### ADDENDUM NO. 1 TO ALL BIDDERS:

Reference – Invitation for Bid: 157389  
Petersburg & South Hill Residency-Restroom  
Renovations  
Commodity: Construction Services  
Dated: December 12, 2022  
For Delivery To: Commonwealth of Virginia  
Virginia Department of Transportation (VDOT)  
Attention: Mr. Joseph Patterson  
Bids Due: **February 21, 2023** (2:00 PM)

## ADDENDUM NO. 01

**RE:** Virginia Department of Transportation  
Petersburg & South Hill Residency – Restroom Renovations  
Project Code: 501-B2501-012  
Information for Bid (IFB) Number: 157389

4 THRESHOLD NO. 2 DETAIL  
3" = 1'-0"

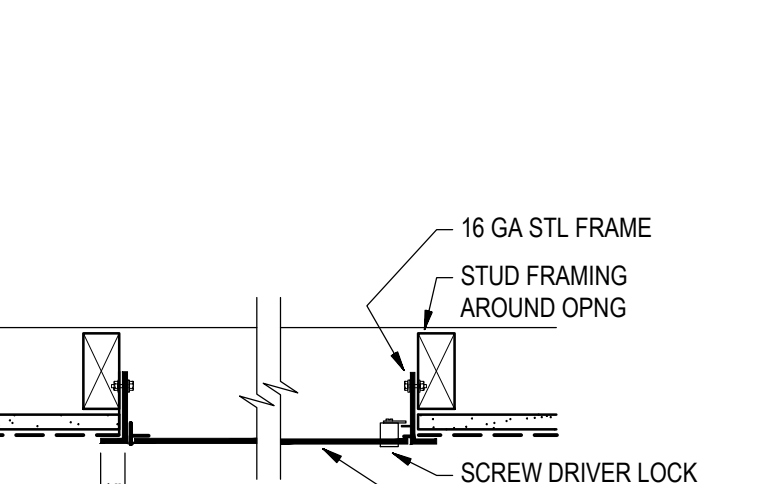
1. **REPLACE DRAWING SHEET A104:** Detail 4 on Drawing Sheet A104 has been revised (attached).
2. **REPLACE DRAWING SHEET A108:** Detail 3 on Drawing Sheet A108 has been revised (attached).
